IDAP REPORT

Property:	25A Wallis Avenue Strathfield LOT 1 DP 534392 DA2021.221
Proposal:	Demolition of existing structures and construction of a dwelling house with basement, swimming pool, front fencing and associated landscaping works.
Applicant:	Vision Group Architects
Owner:	J Hanna
Date of lodgement:	27 August 2021
Notification period:	9 September 2021 - 21 September 2021
Submissions received:	Nil
Assessment officer:	L Gibson
Estimated cost of works:	\$1,757,355.00
Zoning:	R2 – Low Density Residential - SLEP 2012
Heritage:	N/A
Flood affected:	No
Is a Clause 4.6 Variation Proposed:	No
RECOMMENDATION OF OFFICER:	APPROVAL

Figure 13: Proposed basement plan including turntable

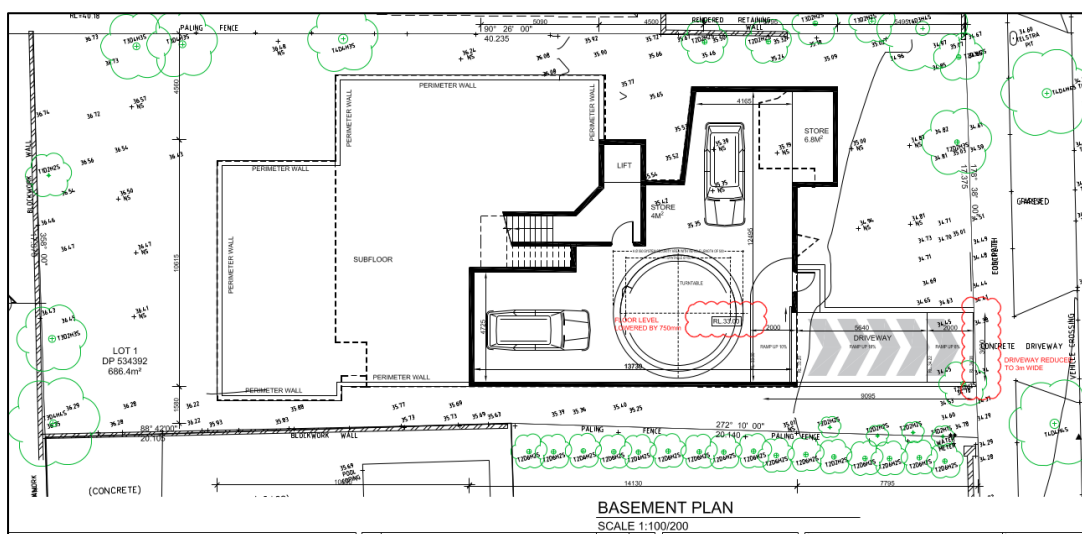
The proposal includes construction of a turntable in the basement (refer to Figure 13 below).

Council's Traffic Engineer raised no objection with the proposal subject to imposition of conditions. This includes a condition requiring a Positive Covenant for Mechanical parking Installations to be imposed on the Title of the property. This is to ensure the turntable is constructed in accordance with the approved design and installation requirements as well as to ensure the ongoing maintenance of the turntable on the property.

Figure 18: Proposed basement design

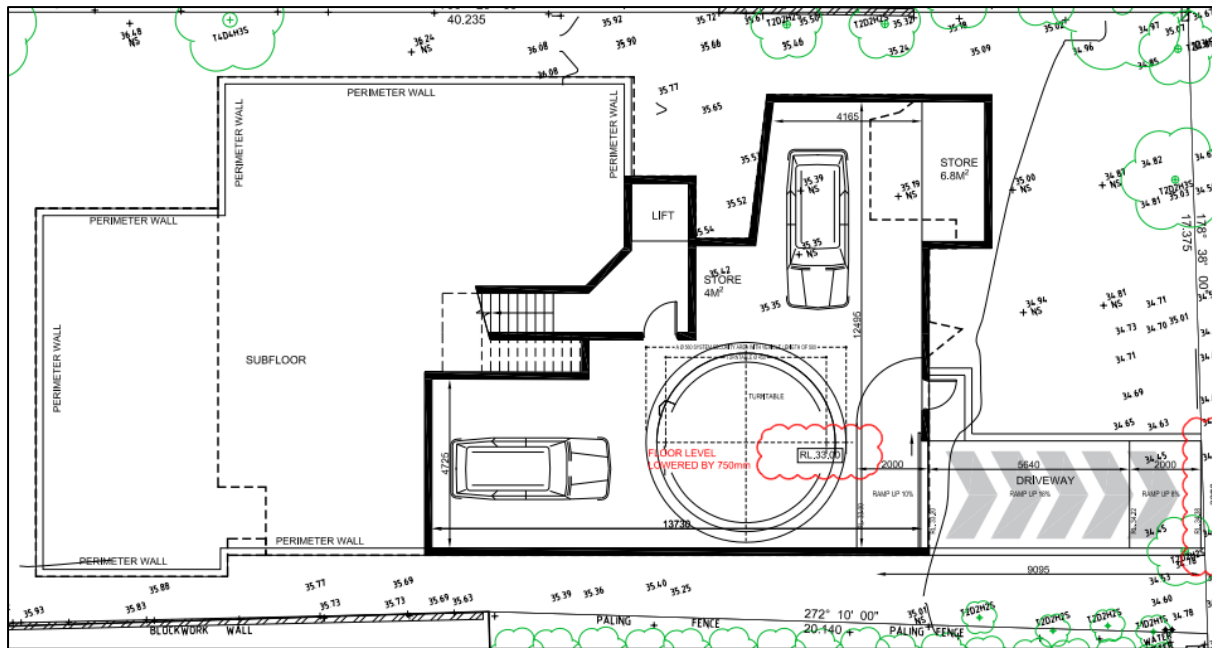
The proposed development satisfies the relevant objectives and controls of the SCDP 2005 in that it provides the minimum number of required parking spaces and adequate vehicular access provisions. The basement design was amended during the assessment process to achieve a compliant 995mm protrusion above NGL. The proposed basement does not exceed beyond the ground floor above and has been designed to enable cars to enter and exit the site in a forward direction (refer to Figure 18 below). A turn table in this instance is considered acceptable and must be maintained via a registered covenant on the site as imposed by conditions of consent. The basement achieves a compliant internal clearance height of 2.32m.
